Attachment 6 of SDP15-00002 Briefing Response Memo

Cover Sheet for SEPA MDNS, Stakeholder Comments to MDNS and Staff Responses

The following documents are included in this attachment set to the Briefing Response Memo for SDP15-00002, Issaquah Gateway Apartments, dated Sept. 16, 2015

Permit Number: SDP15-00002 – Gateway Apartments

DESIGN	DRAWN DRT	PROJECT 634C
SCALE 1 in : 80 ft		
DATE 17 AUG 2015		1
REVISED

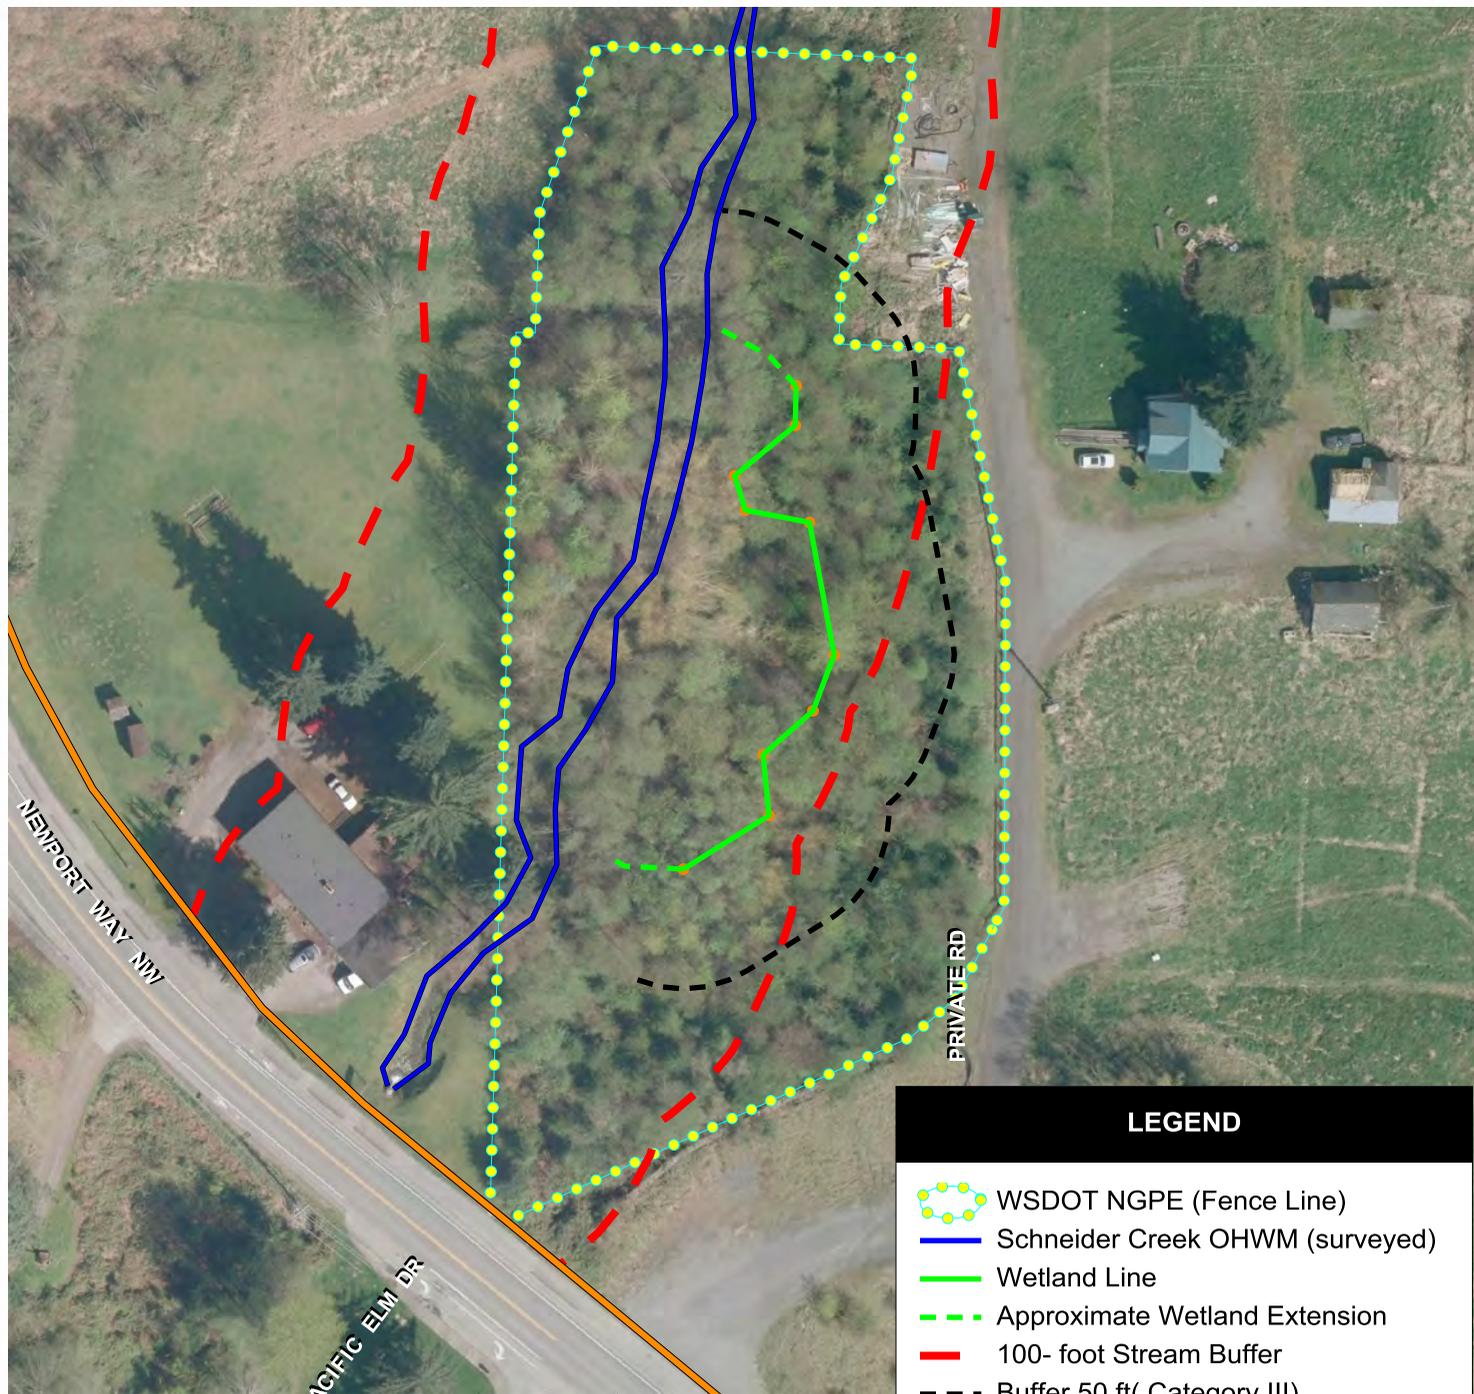
On Page 4, the top paragraph contains an erroneous statement in regard to the potential for Schneider Creek to provide spawning, winter rearing, or refugia for salmonids on the Gateway property. The exact text reads as follows:

Comment: This conclusion is not what was provided in our Critical Areas Report. Our report **does not** say that there is no spawning, rearing, or refugia habitat for anadromous fish in the onsite reach of Schneider Creek. Our text does mention that the onsite reach of Schneider Creek from the I-90 right-of-way to the WSDOT NGPE is **limited** in its ability to provide winter rearing or refugia for anadromous fish due to existing stream morphology, gradient, and lack of pools. This is an important distinction in describing current site conditions.

On Page 4, the last sentence in paragraph 1 states: “The outer stream buffer shall be planted at a minimum of **60% of the planting density** [emphasis added] to allow for visibility to the stream buffer trail (see below) and to transition to the developed part of the site.”

Comment: Per a review memo provided by Peter Rosen on June 24, 2015, he states under Item 7 Critical Areas – 6) Schneider Creek Buffer Enhancement – The outer buffer can be planted at **50% of this density** [emphasis added], to transition to the development area and to accommodate the trail. We agreed to the 50% density

“[t]he stream channel is currently confined and incised and the streambanks **could** [emphasis added] be graded back to allow natural stream processes to create meanders within the buffer area. A final grading plan for the stream buffer and the proposed berm **shall also address grading back the streambanks** [emphasis added] to allow natural stream processes to create meanders within the buffer area”.

Comment: It has always been the intention of our stream buffer mitigation plan to allow natural processes to create the meanders and not to do any work within the ordinary high water mark (OHWM) to create this type of habitat. As the Applicant stated in the River and Streams Board Public Meeting of 21 July 2015, “[w]e are not proposing habitat improvements within the channel.” The suggestion that the stream banks **could** be graded back to allow natural stream processes would involve work within the OHWM of Schneider Creek and would require additional permitting from the Washington Department of Fish and Wildlife, the Army Corps of Engineers and additional public and tribal comment. This would constitute the very habitat improvements within the channel of Schneider Creek that the applicant categorically stated during the River and Streams Board Meeting would not occur. In fact, Peter Rosen responded to a question by either a Board Member or a member of the public that they (the client) are not proposing any work below the OHWM within the stream channel (personal conversations with Bill Shiels and Ann Olsen of Talasaea). Both Mr. Rosen and Ms. Tarce were present at that meeting.

It is our intent to allow natural processes to develop a natural stream channel within the limits provided by the proposed berm, plantings and the placement of large woody debris. We anticipate that the current movement of bed load onto and through the onsite reach of Schneider Creek will provide a sufficient natural mechanism to create biologically significant meanders and resultant geomorphic instream habitat features. We also anticipate that the onsite reach of Schneider Creek will also recruit woody debris from upstream as the channel morphology naturally develops. We respectfully request that the SEPA MDNS be revised to remove the suggestion to grade the streambanks.

We respectfully request that the SEPA MDNS be revised to replace the erroneous statement (highlighted in bold text above) with the wording we provided in our report on Page 15, Section 5.2.2.1 within the paragraph entitled **Schneider Creek Classification**.

Comment: As stated earlier, we will not be grading back the streambanks below the OHWM. We respectfully request that the SEPA MDNS be revised to remove the suggestion to grade the streambanks.
